UNITED STATES  
NUCLEAR REGULATORY COMMISSION  
WASHINGTON, D. C. 20555  
November 30, 1977

Dockets Nos.: 50-247  
and 50-286

The Commission has issued the enclosed Amendment No. 36 to Facility Operating License No. DPR-26 and Amendment No. 10 to Facility Operating License No. DPR-64 for the Indian Point Nuclear Generating Units Nos. 2 and 3, respectively. These amendments consist of changes to the Technical Specifications in response to your applications transmitted by letters dated July 20, 1977.

Amendment No. 36  
License No. DPR-26

Figure 6.2-1 Facility Management and Technical Support Organization

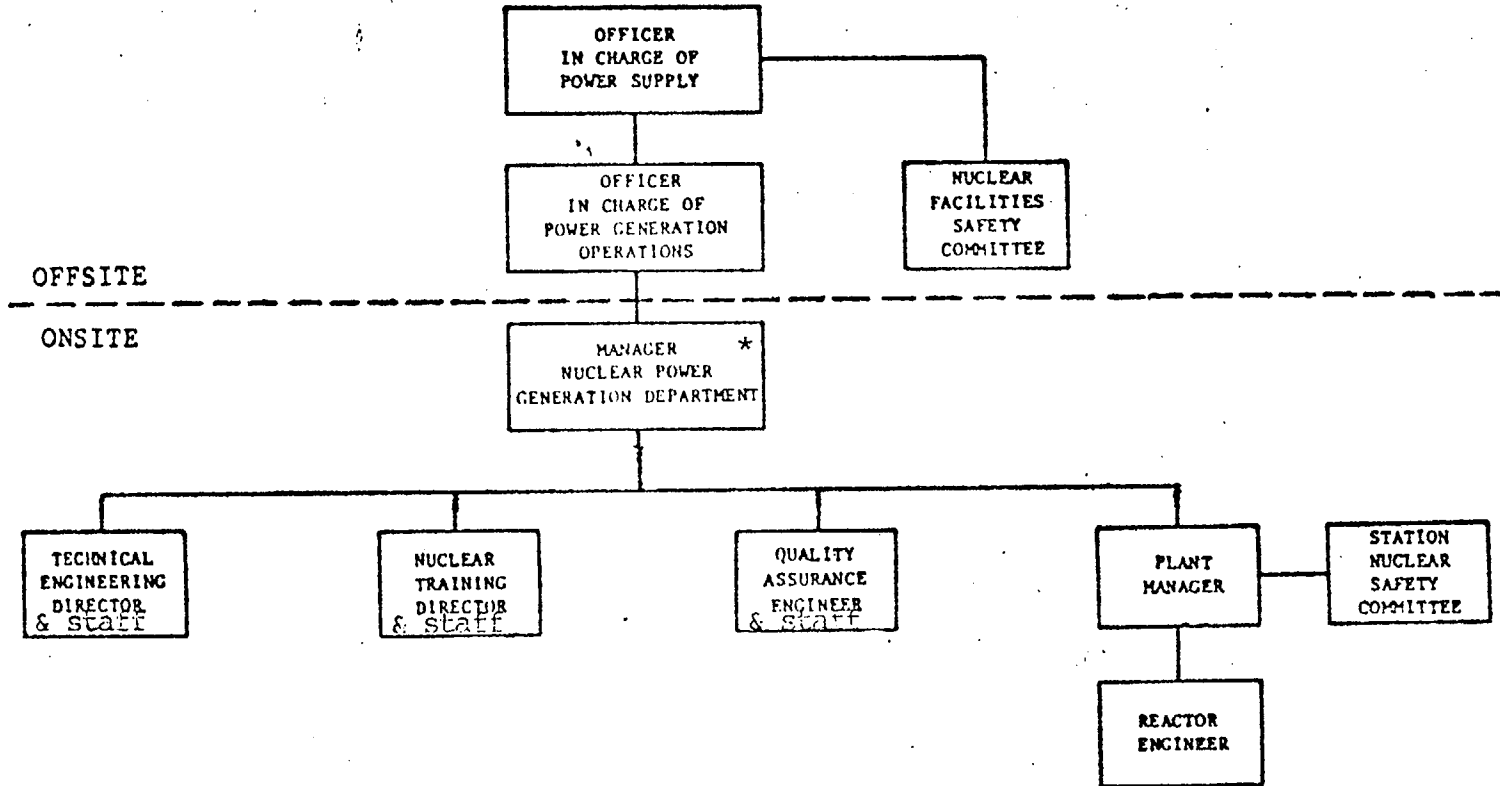
6.2.1 The organization for facility management and technical support shall be as shown on Figure 6.2-1.

\* Responsible for performance and monitoring of the Fire Protection Program

Figure 6.2-1 Facility Management and Technical Support Organization

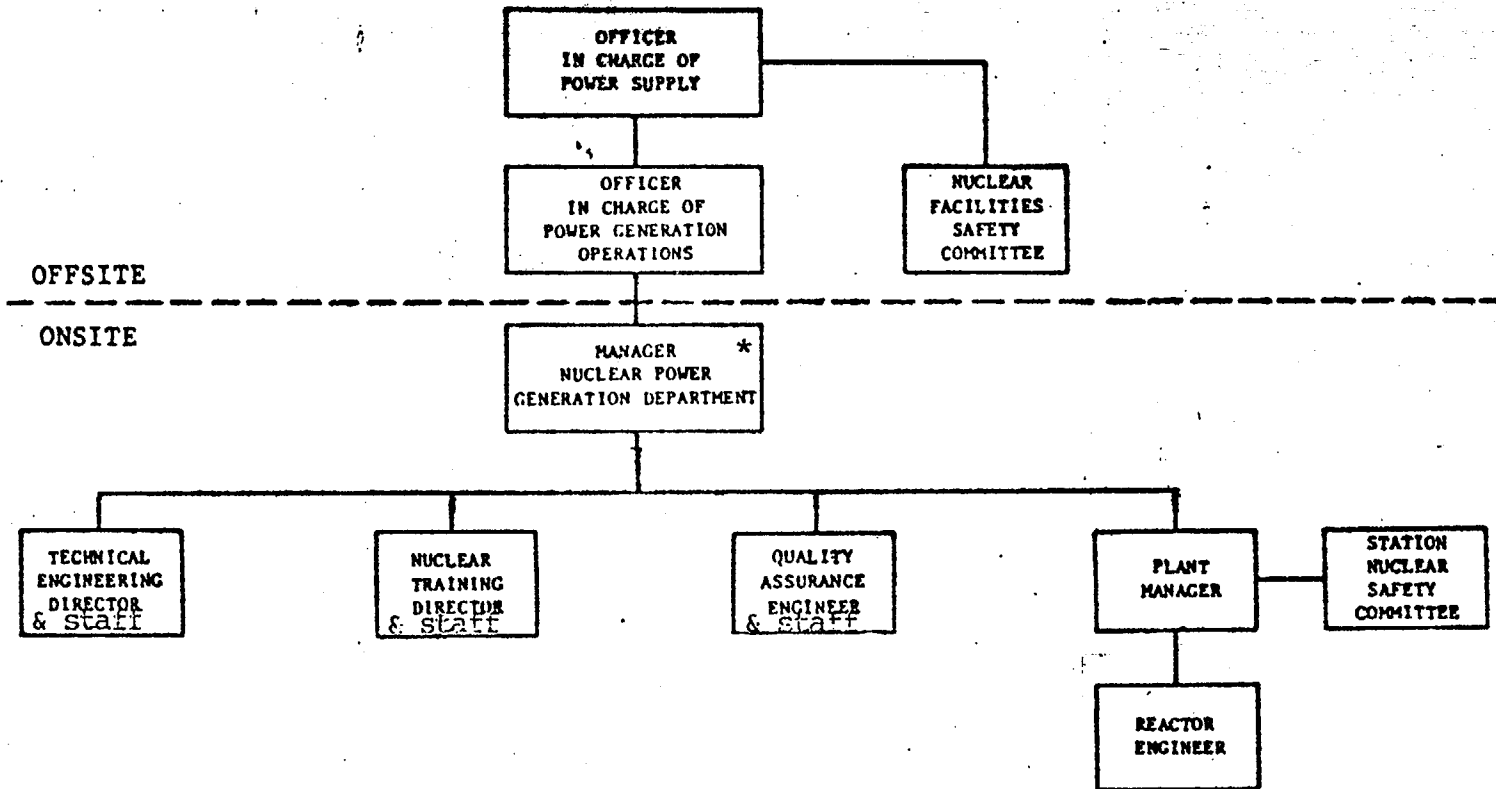
6.2.1 The organization for facility management and technical support shall be as shown on Figure 6.2-1.
